Proposed Revisions to a Standard Plans Index

Index Number: 649-010

Index Title: STEEL STRAIN POLE

ELEVATION AND NOTES

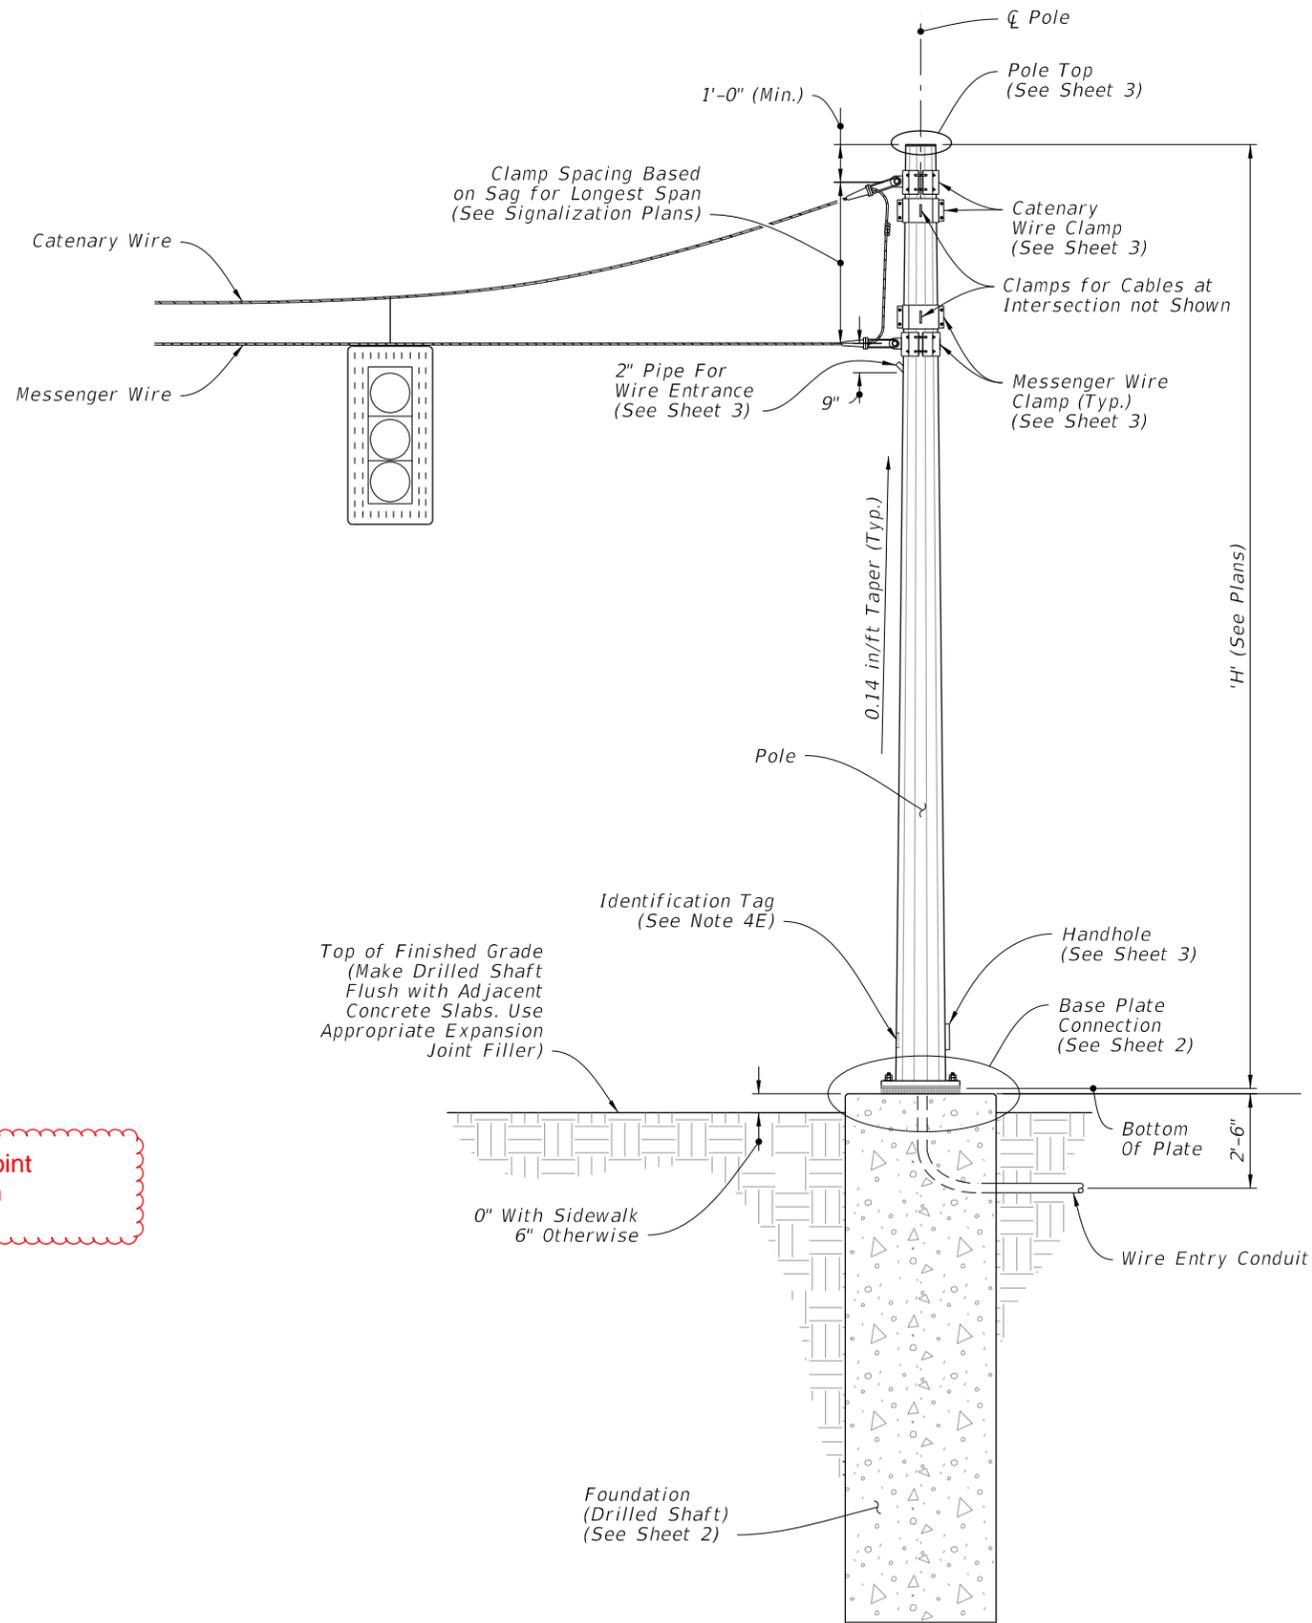
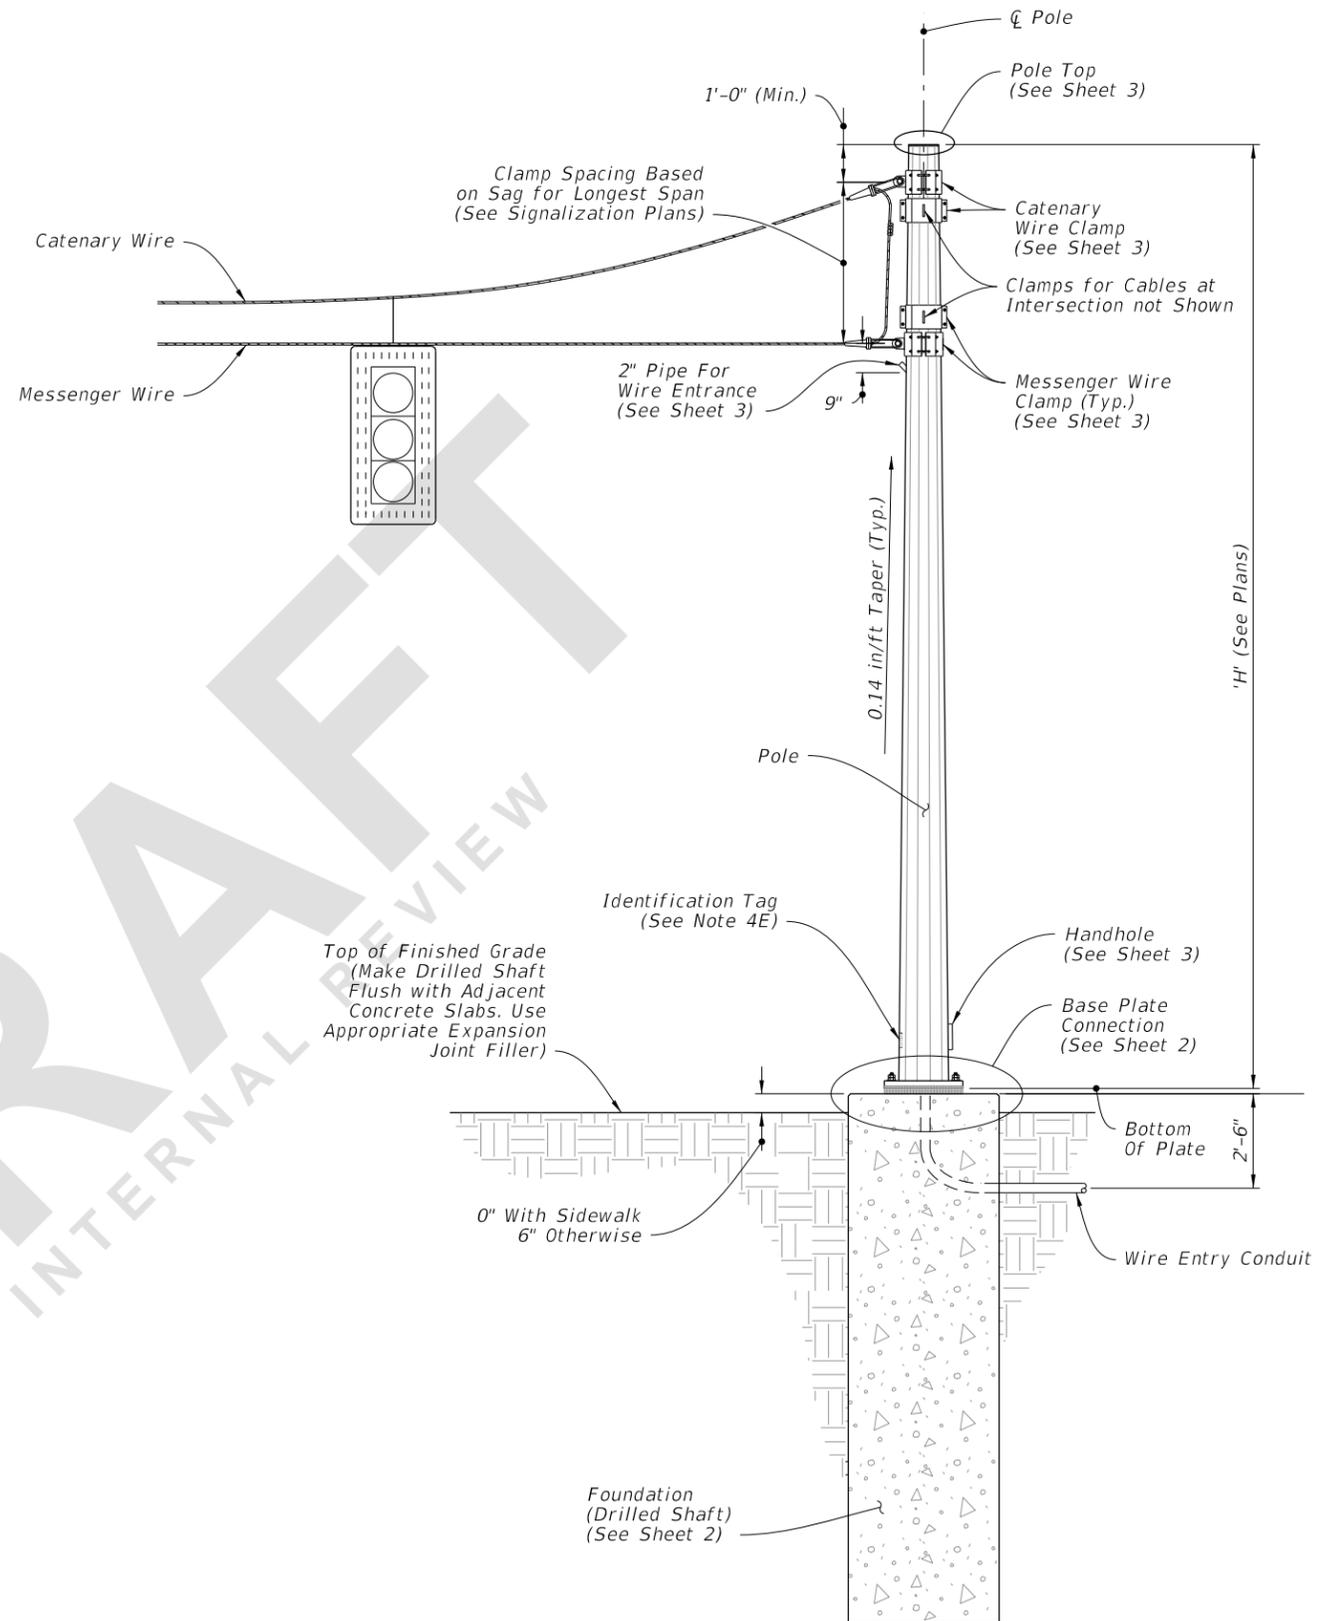
Sheet 1: Changed phrase from "full-penetration groove" to "complete joint penetration".

Sheet 1: Changing non-standard language to standard language consistent with AWS.

H. Fabricate longitudinal seam welds in pole with 60 percent minimum penetration or fusion welds except, within 6" of the base plate connection use full-penetration groove welds.

complete joint penetration

H. Fabricate longitudinal seam welds in pole with 60 percent minimum penetration or fusion welds except, within 6" of the base plate connection use complete joint penetration welds.

ATTACHMENT DETAILS

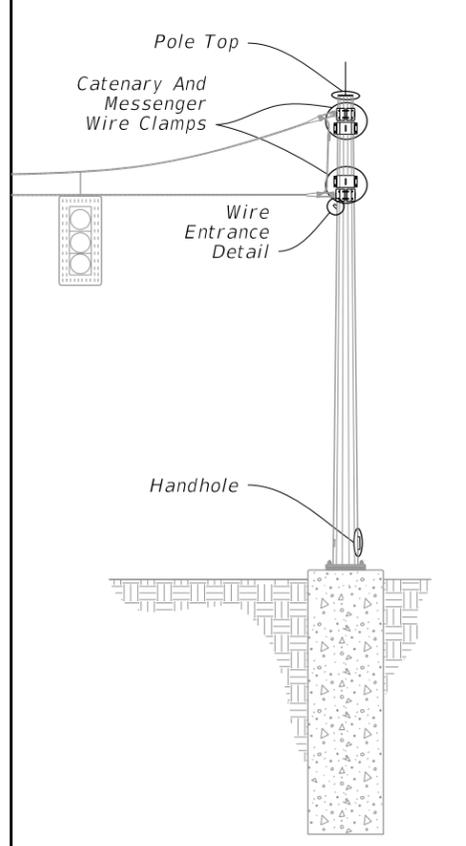
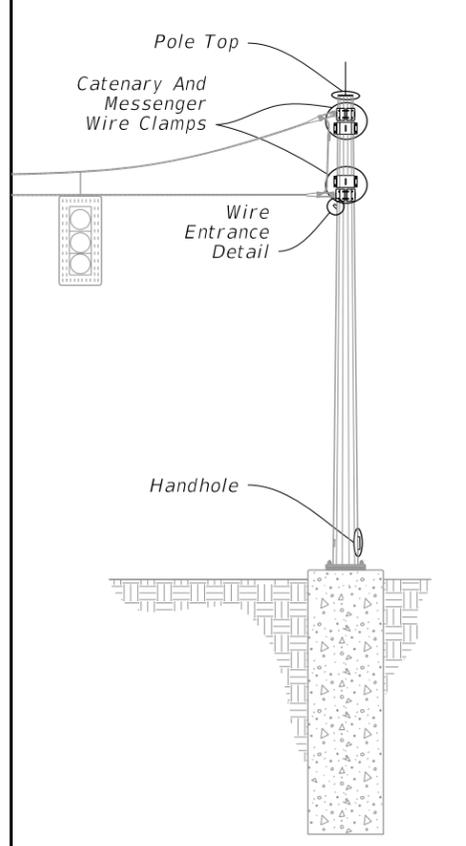
Sheet 3: Changed weld detail to say "CJP."

Sheet 3: Changing non-standard language to standard language consistent with AWS.
